# CONSERVATION COMMISSION AGENDA

August 26, 2021

- Request: Issue an OOC.
3. **(7:25) Levingston Cove (Crystal lake) – NOI – park improvements – DEP File #239-901**
  - Owner: City of Newton Applicant: Luis Perez Demorizi, Open Space Coordinator

Project:  
**IMPROVEMENTS TO LOUISE LEVINGSTON COVE**

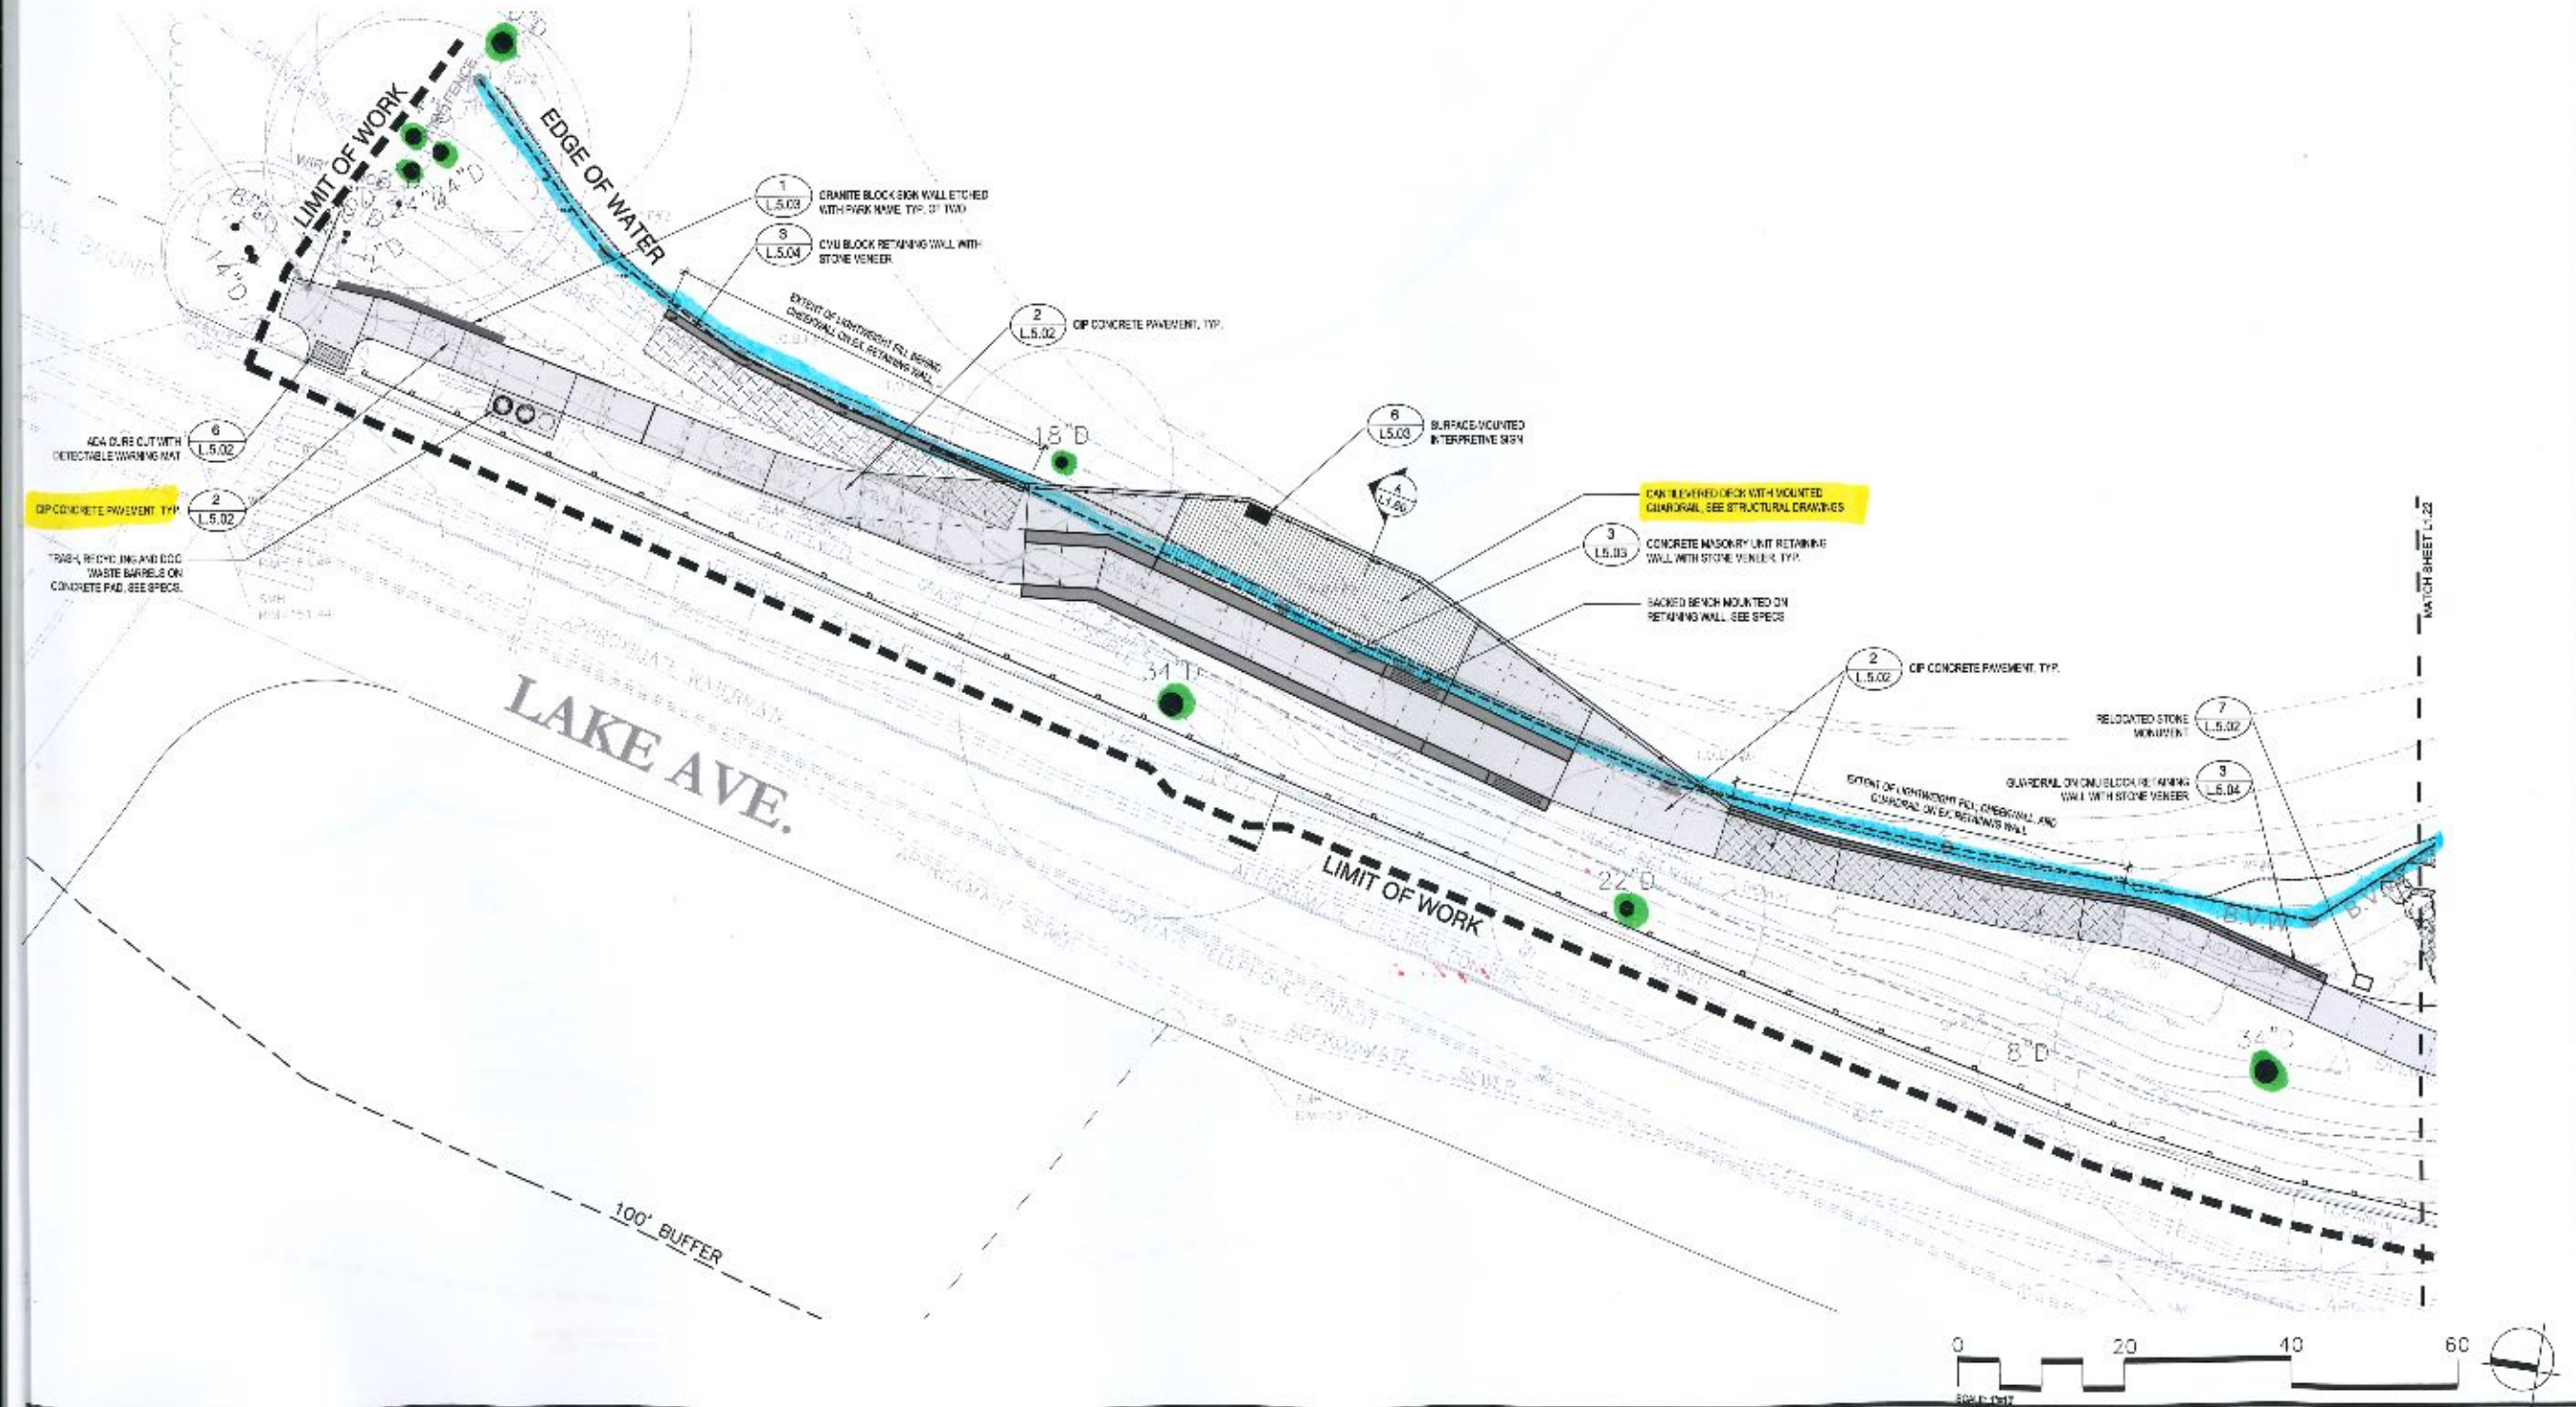
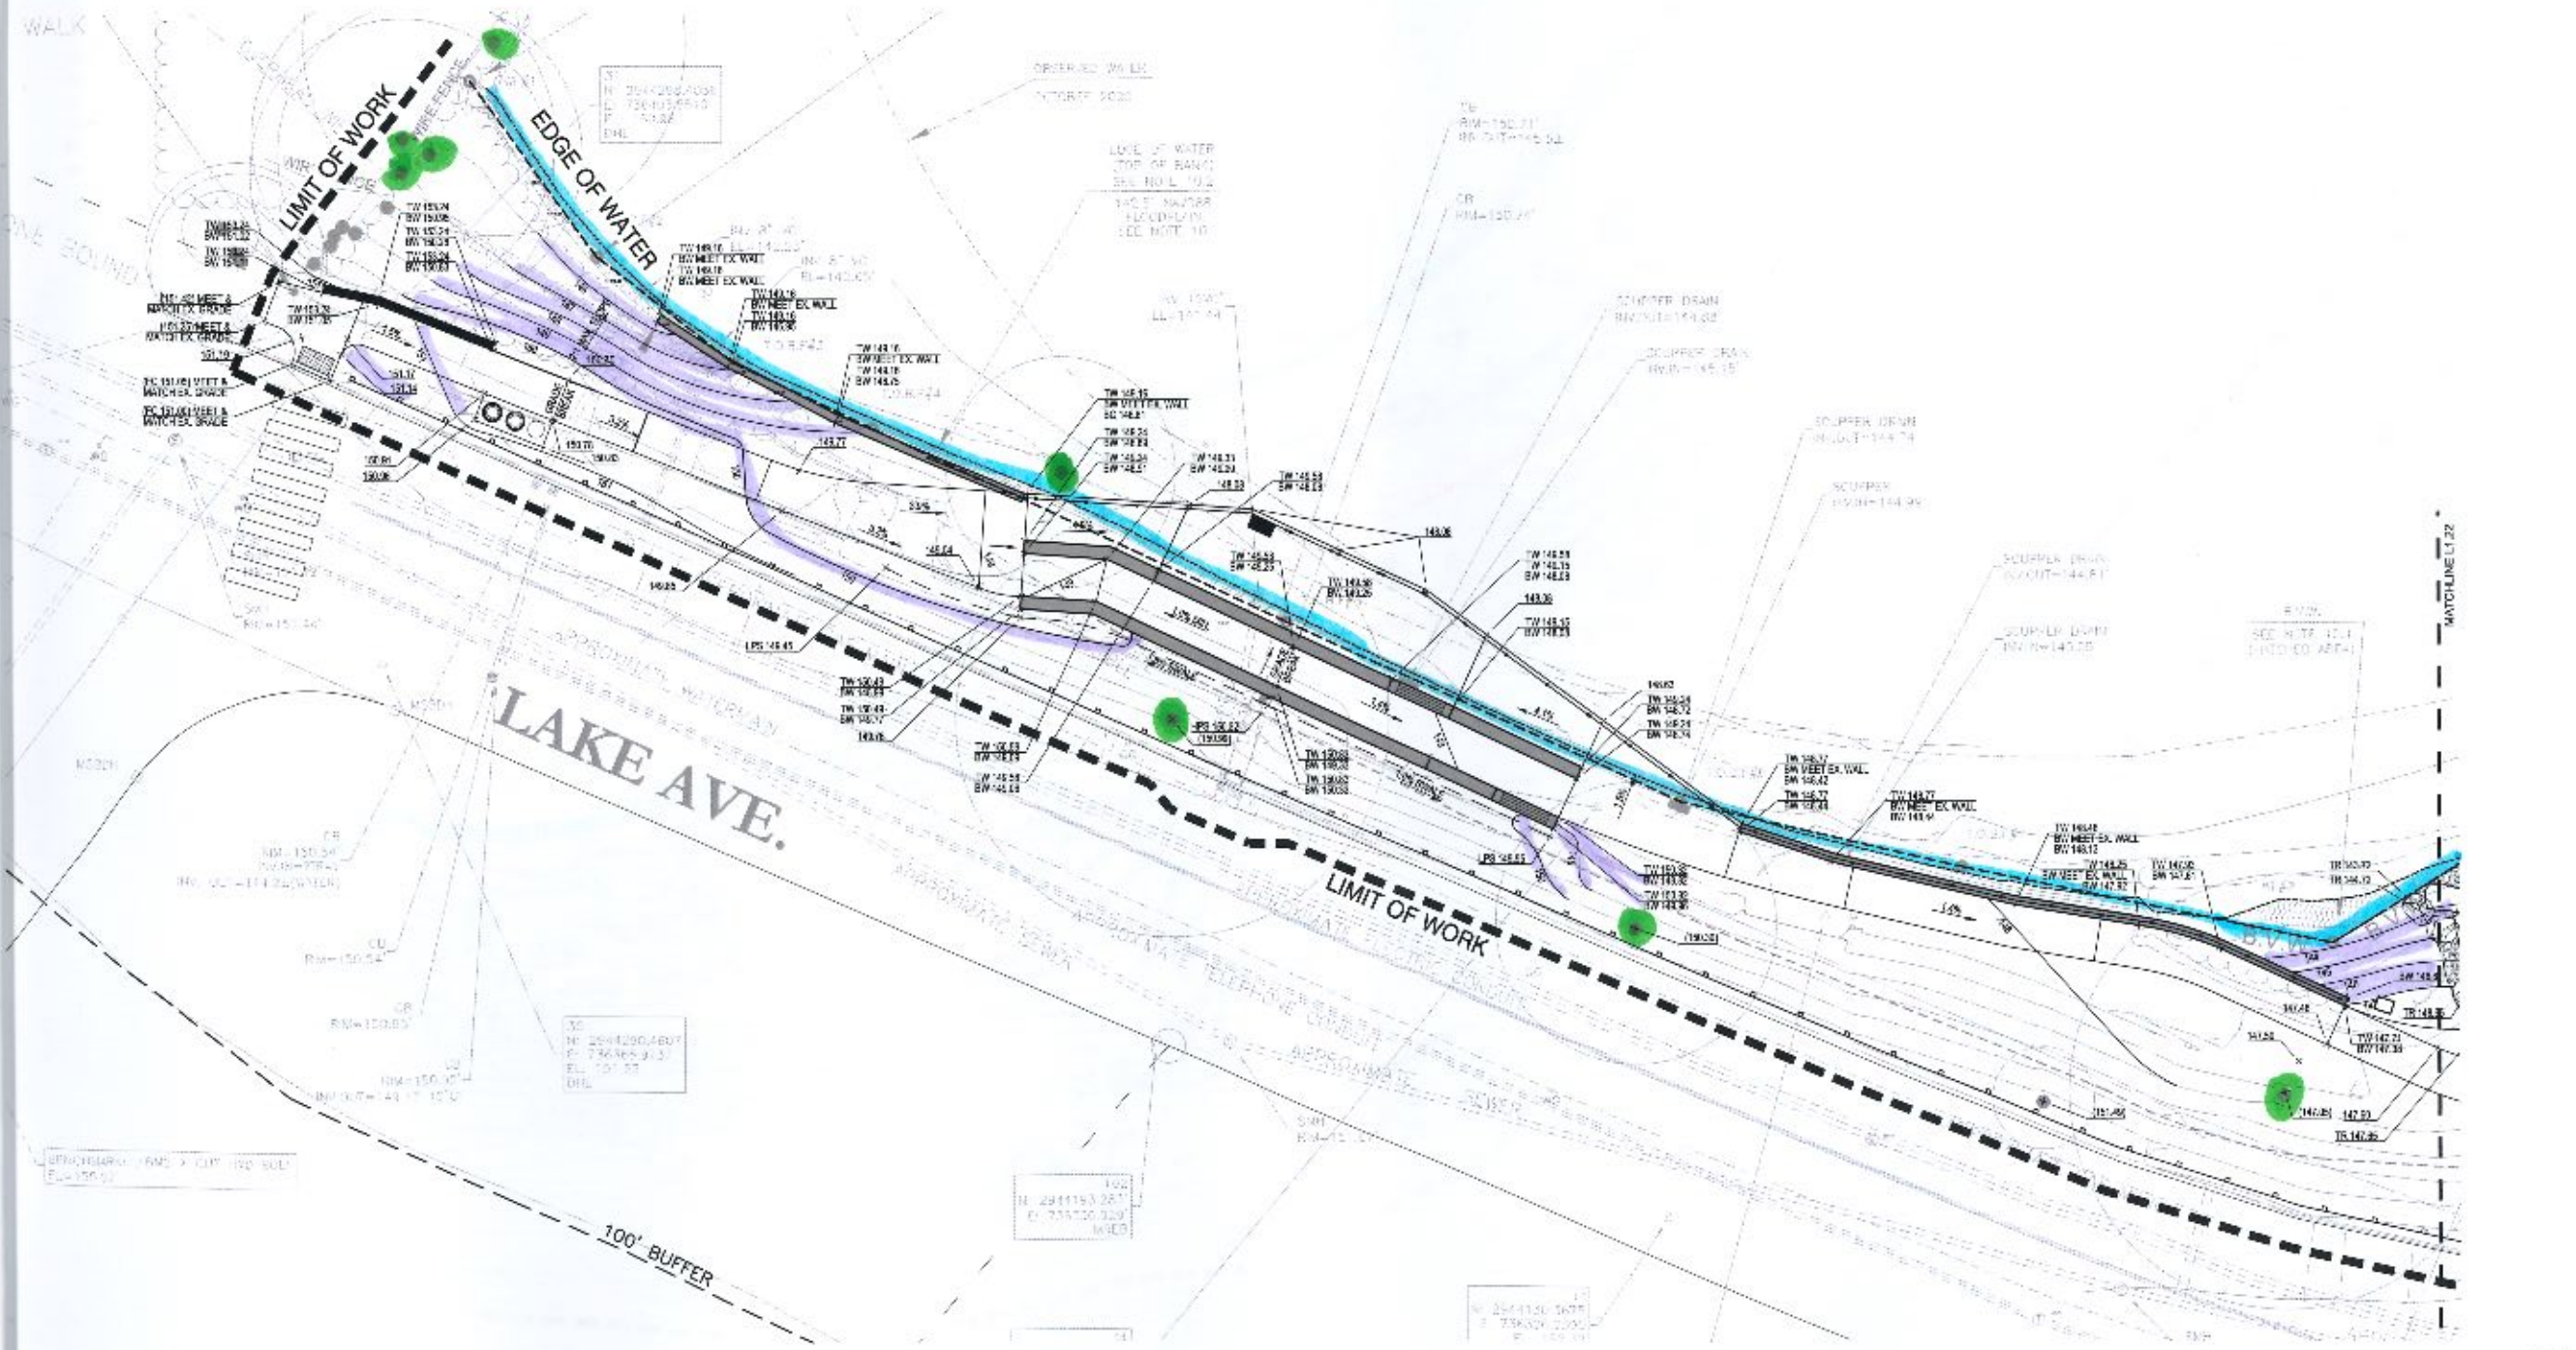
- In the narrative (and on the plans, as appropriate) the applicant should expand descriptions of anticipated processes such as:
    - Excavation
    - Stockpiling

- The applicant should clarify:
    - chapter 91 status,
    - anticipated timing of the work,
    - what work is proposed in the BVW (L1.11), and
    - tree protection (L1.11 and L5.00).

- What the "add alt – cofferdam with sandbags" (L1.10) pertains to? (stone veneer work?)
- What treatment methods and timing are planned for invasive species removal?

- What "synthetic turf reinforcement material" (narrative pg 2) is? (the 70-21-10 soil mixture?)
- Where the cross-sections A-D are located on the plan view?

- L5.07 – Turf Reinforcement detail. "tree mix"? (seed mix?) – please add the specs to the plan.
- S101 – "Section through pile cap" detail say "embed micropiles 6". Is that correct?

- S101 – is the cantilevered deck secured with bolts, not "deadmen"?
- Suggested plan and narrative changes:
  - Change in the narrative and L1.10 "straw wattles" to "staked silt fence and staked compost sock"

- The narrative states (confusingly) that the City Floodplain is at 149'. It is, on the CNVD. But that is 142.5' NAVD88, the datum of the plans. Therefore, the cut and fill information in the narrative pages 4&5 is inaccurate.

- Add cofferdam details.
  - Add the Turf Reinforcement specs to the plan.
  - Add dewatering information.
  - Add stockpiling locations.
- Staff Recommendations: Await responses to staff notes (and Commissioners' questions).
